TECHNICAL SERVICE BULLETIN

Technical Service Bulletin: 215-1668

Forest River is alerting you to an issue involving certain 2023-2024 Coachmen Cross Trail Class C Recreational Vehicles. Please see the information below, which describes the issue and provides you with details on the steps you should take to have your vehicle repaired.

Title: REGO Over Discharge

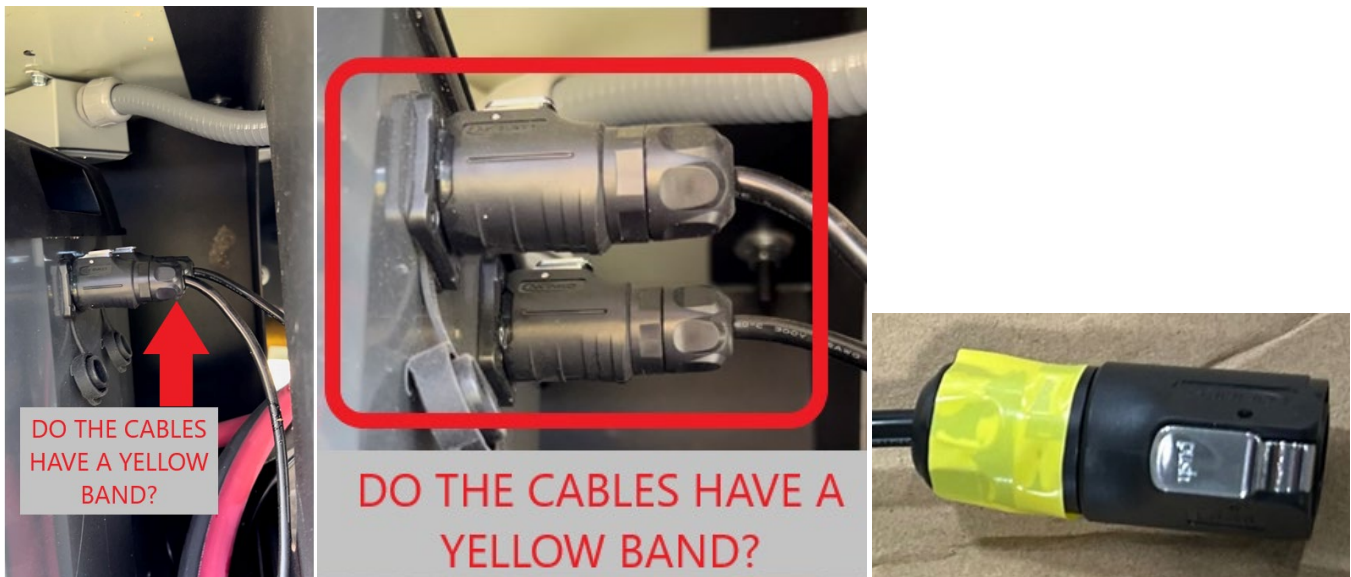
Non-isolated ground path in the battery, a ground path via the CAN cabling. The battery has a negatively switched BMS, meaning that when the BMS interrupts the negative path of the circuit between the cells and the battery (-) terminal. Certain components can ground via the CAN PS- in the CAN cabling. This can happen when the battery shuts down in low voltage protect mode.

Modify the RVC cabling by cutting the PS(+) and PS(-) wires inside the connectors. This would immediately remove the potential for the parallel ground path through the RVC wiring, and allow the battery to correctly isolate itself from the loads, to prevent further over discharge.
